# 21-COA-0121 2409 Ransdell Ave.

Cherokee Triangle Architectural Review Committee
Public Hearing

Bradley Fister, Historic Preservation Specialist August 11, 2021

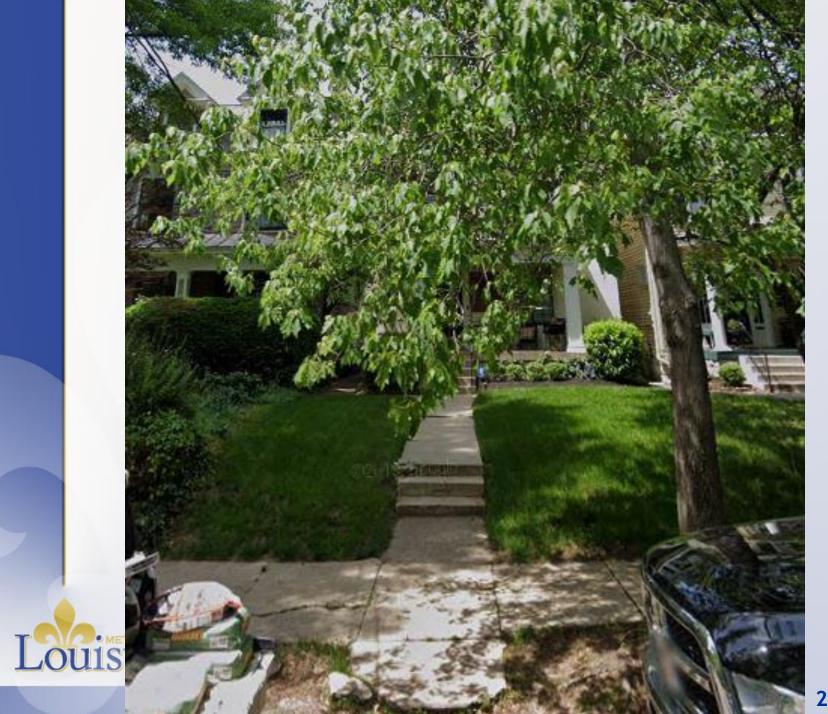
The applicant seeks approval for an afterthe-fact 2' tall retaining wall, constructed of brick and historic mix mortar.

The after-the-fact changes to the property have been found not to meet the design guidelines for the Cherokee Triangle Preservation District. Staff determined that the proposed work is not appropriate for this property at this time. If deemed necessary, a lower curb-style border would be more in keeping with the Design Guidelines.

Per the Cherokee Triangle Site Design Guidelines, ST-8 states to maintain original front yard topography, including grades, slopes, elevations, and earthen berms where present, and ST-10 which states not to install masonry walls in street-visible locations unless they are used to retain earth at changes in grade, screen service areas, or unless a historic precedent exists. The applicant was aware a COA is required for all exterior changes to the property prior to construction. The applicant has also not

The applicant was aware a COA is required for all exterior changes to the property prior to construction. The applicant has also not provided evidence for the need of a retaining wall or justification for its height.

Based on the information furnished by the applicant, staff recommends the application for a Certificate of Appropriateness be **denied**.
